ATTACHMENT 2 TO AEP:NRC:0860

REVISED PAGES WHICH THE
TECHNICAL SPECIFICATION CHANGES
FOR DONALD C. COOK NUCLEAR PLANT
UNIT NO. 2 CYCLE 5

FIGURE 3.2-4 RCS TOTAL FLOWRATE VERSUS R - FOUR LOOPS IN OPERATION

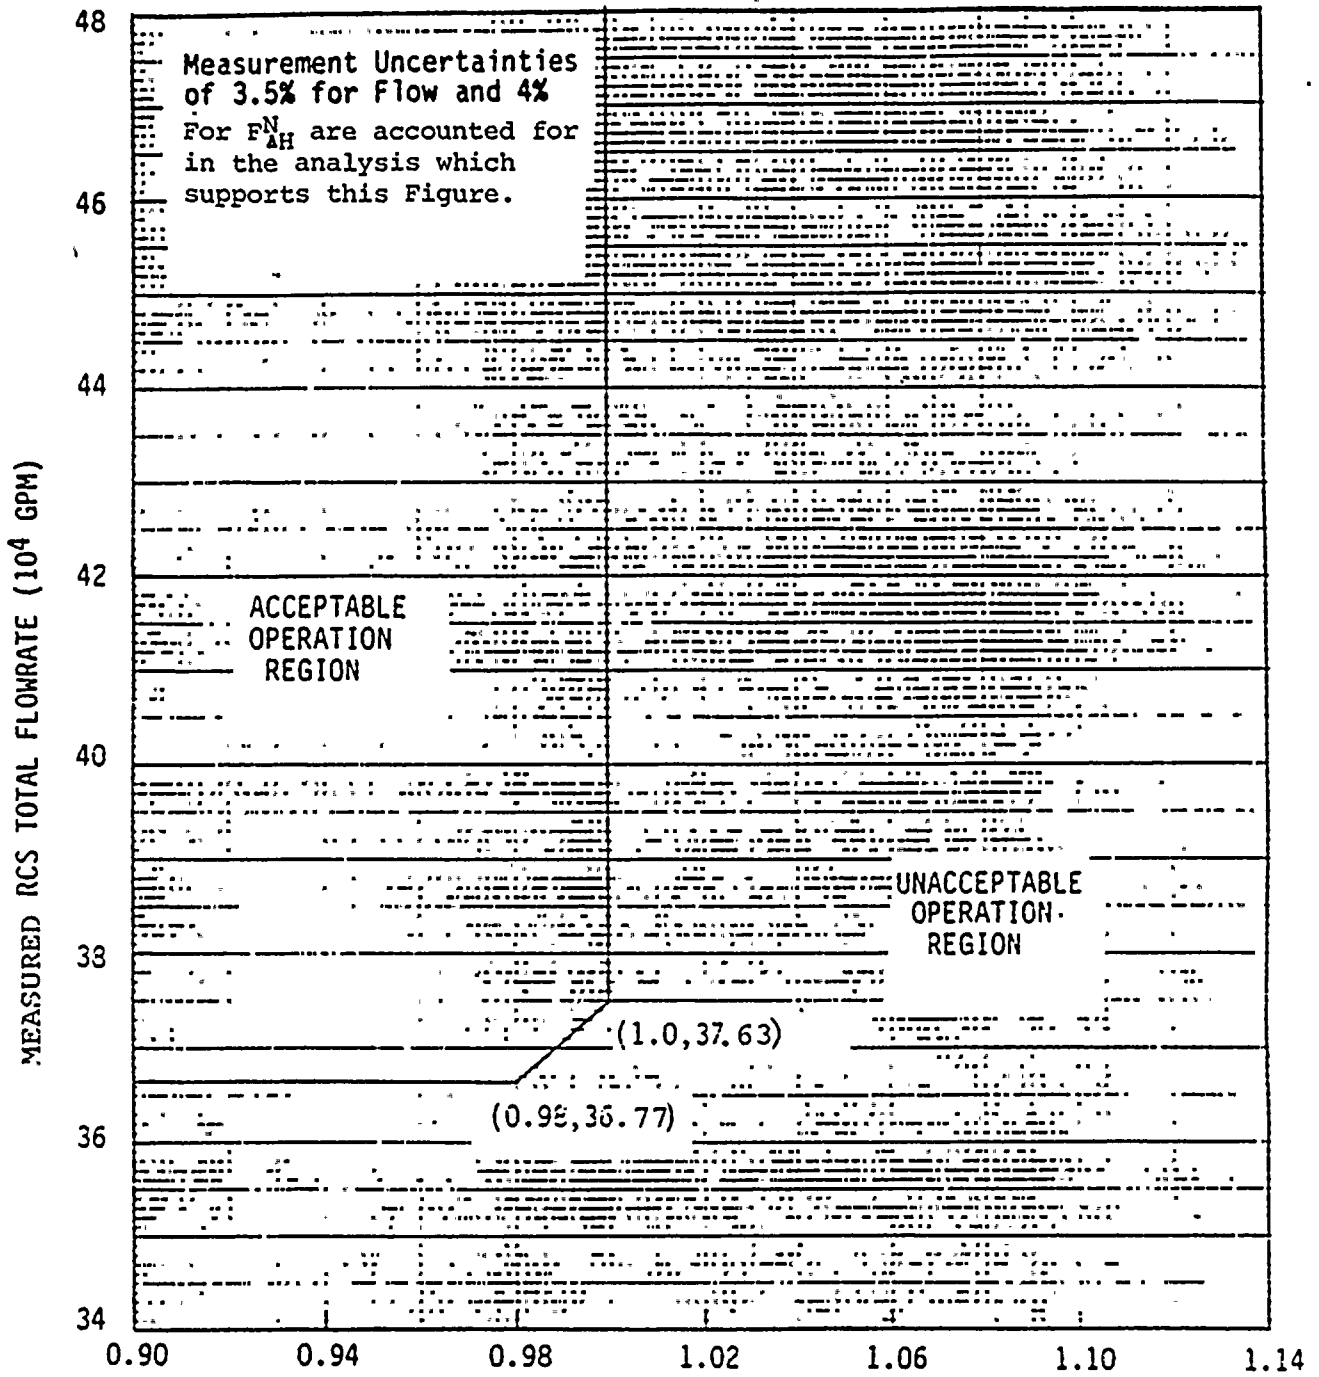
$$R = F_{\Delta H}^N / 1.48 [1.0 + 0.2(1.0 - P)] \text{ WESTINGHOUSE FUEL}$$

$$R = F_{\Delta H}^N / 1.49 [1.0 + 0.2(1.0 - P)] \text{ EXXON NUCLEAR CO. FUEL}$$

FIGURE 3.2-5 RCS TOTAL FLOWRATE VERSUS R - THREE LOOPS IN OPERATION

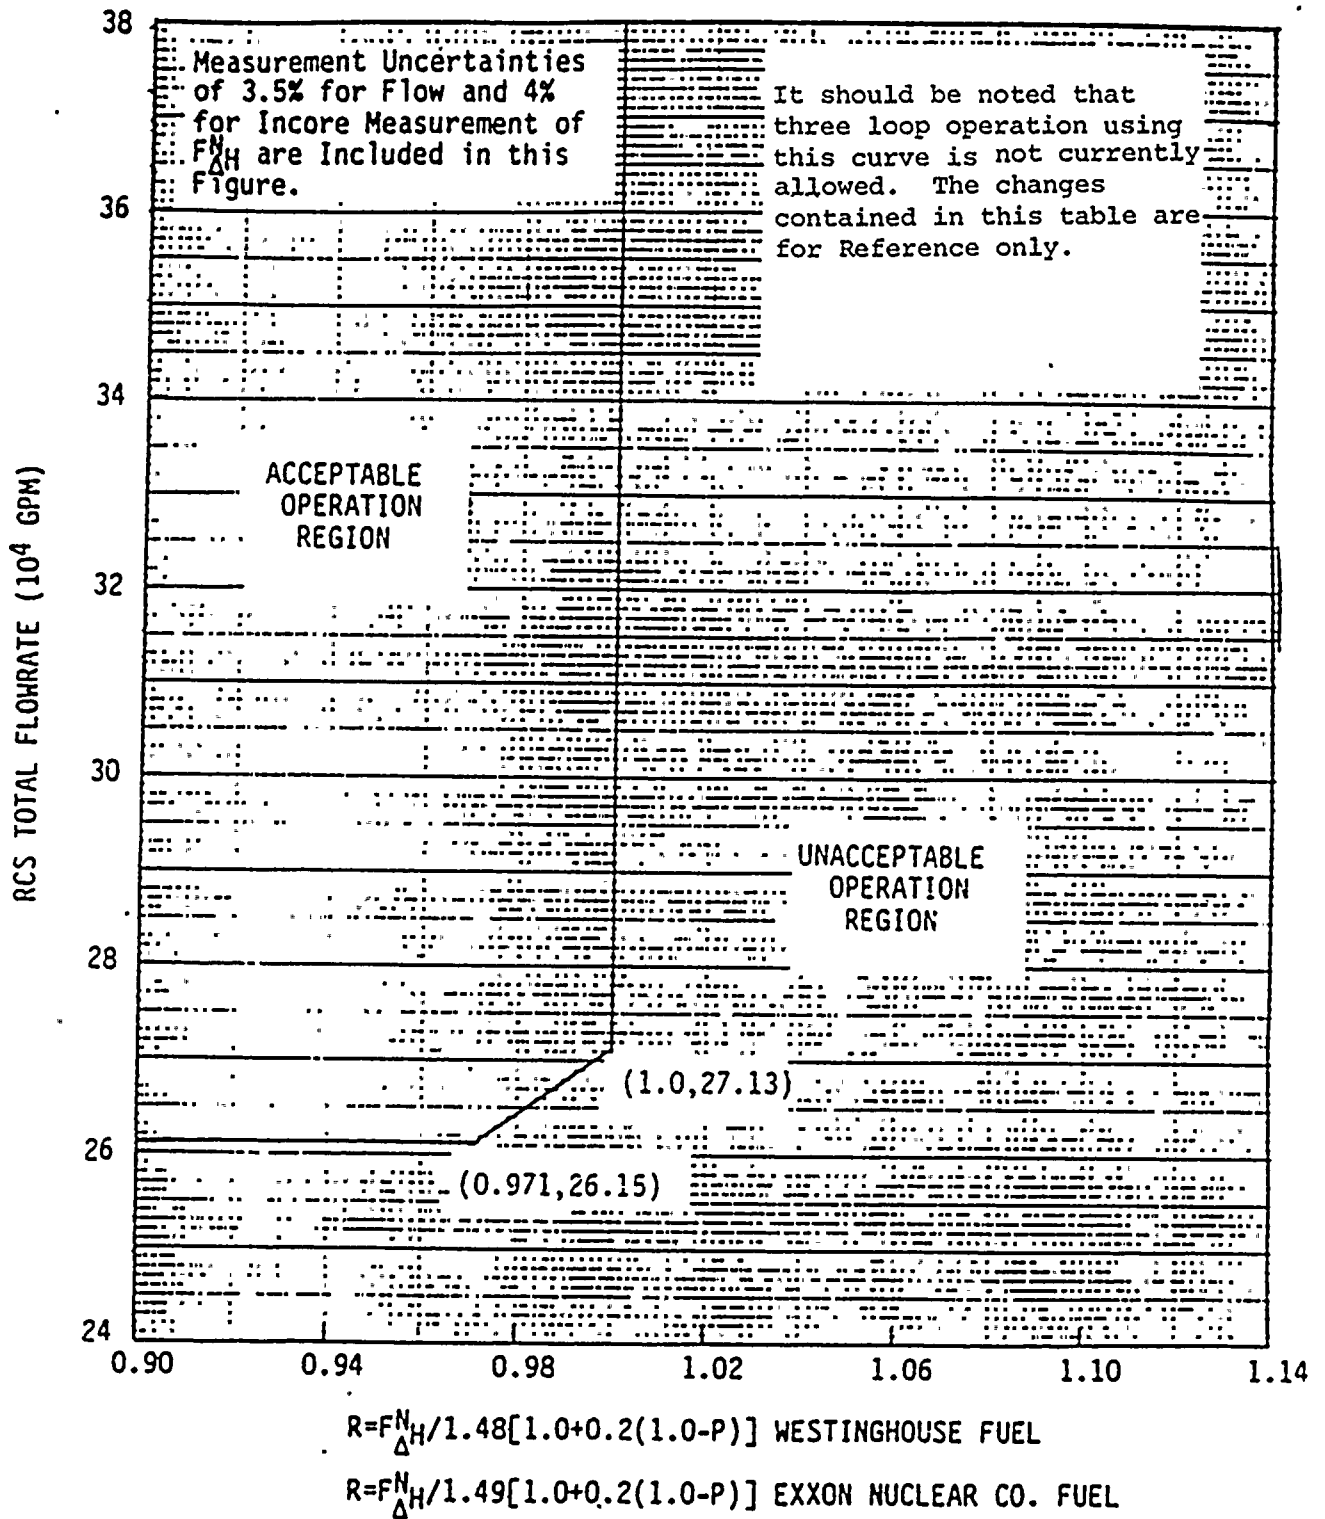
$F_{\Delta H}^N$ will be maintained within its limits provided conditions a. through d. above are maintained. As noted on Figures 3.2-4 and 3.2-5, RCS flow rate and $F_{\Delta H}^N$ may be "traded off" against one another (i.e., a low measured RCS flow rate is acceptable if the measured $F_{\Delta H}^N$ is also low) to ensure that the calculated DNBR will not be below the design DNBR value. The $F_{\Delta H}$ limit in combination with the F_Q limit of 2.04 ensures compliance with the ECCS acceptance criteria. The relaxation of $F_{\Delta H}^N$ as a function of THERMAL POWER allows changes in the radial power shape for all permissible rod insertion limits.

When RCS flow rate and $F_{\Delta H}^N$ are measured, no additional allowances are necessary prior to comparison with the limits of Figures 3.2-4 and 3.2-5. Measurement errors of 3.5% for RCS flow total flow rate and 4% for $F_{\Delta H}^N$ have been allowed for in determination of the design DNBR value. Measurement error of 4% for $F_{\Delta H}$ has been allowed for in determination of the ECCS limits.
